1963 - 1967 Corvette: Service News: Corvette Coupe Body Rework for Larger Racing Tires (Rear Wheels)

Model and Year: 1963 - 1964 Corvette

Source: Chevrolet Service News

Date: August 1964, Volume 36, Issue Number 7

Fig. 2—Rework of 1963-64 Corvette Model 837 for Installation of Larger Tires

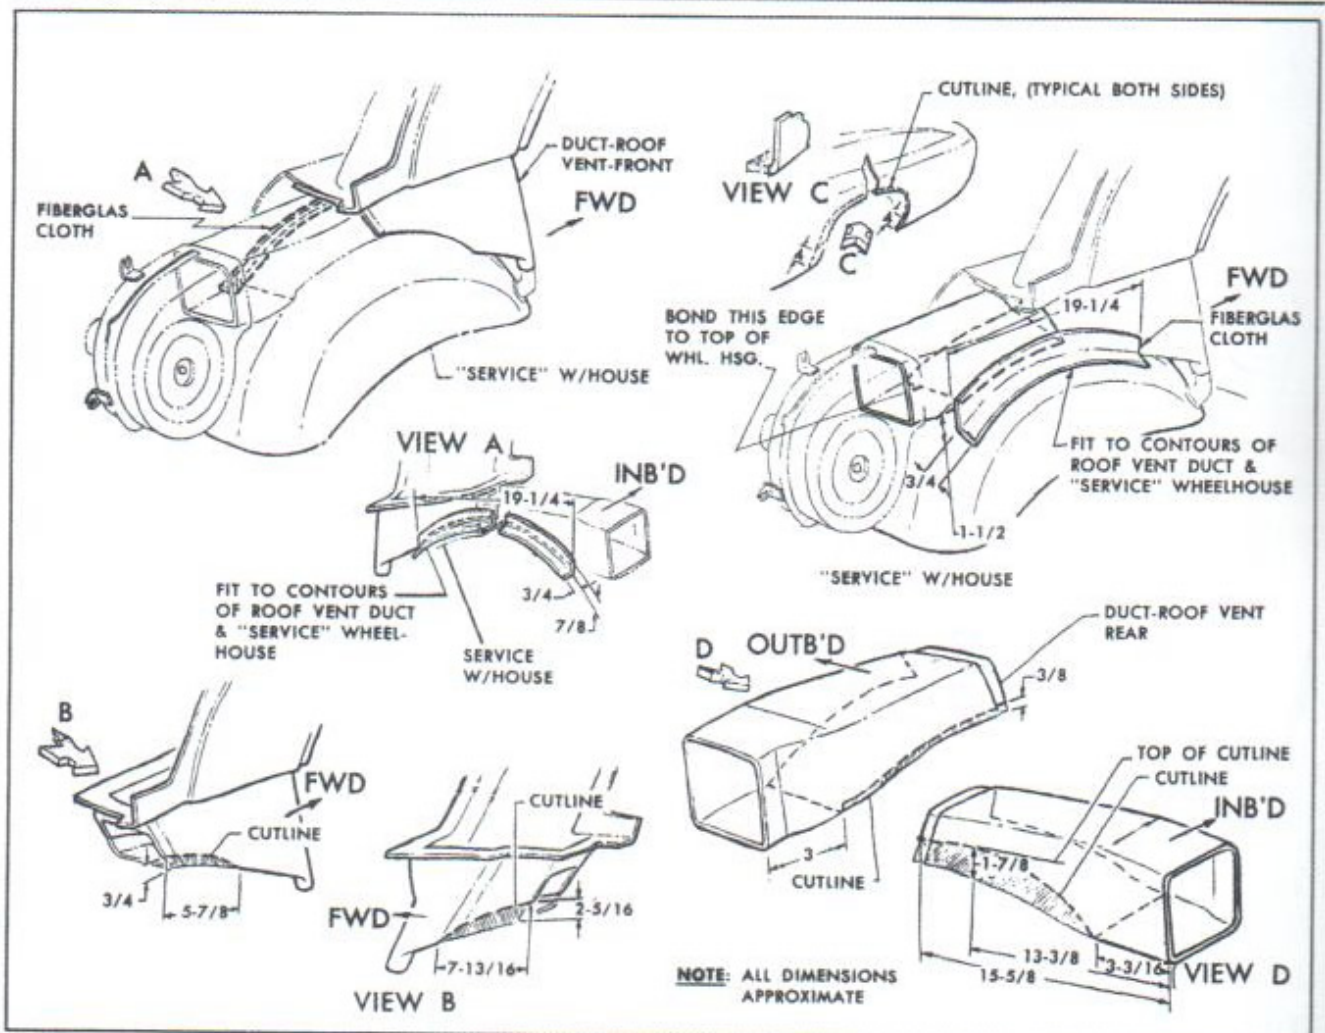
Refer to Figure 2 for details of the installation of the larger wheel housings, the provision of extra clearance between the tire and wheel openings, and the

modification of the body rear compartment air exhaust duct. In those areas where cutting and rebonding of fiberglass is involved, regular shop practices and materials should be used. The use of the materials show in Group 12,800 of the Chevrolet Parts Catalog is suggested.
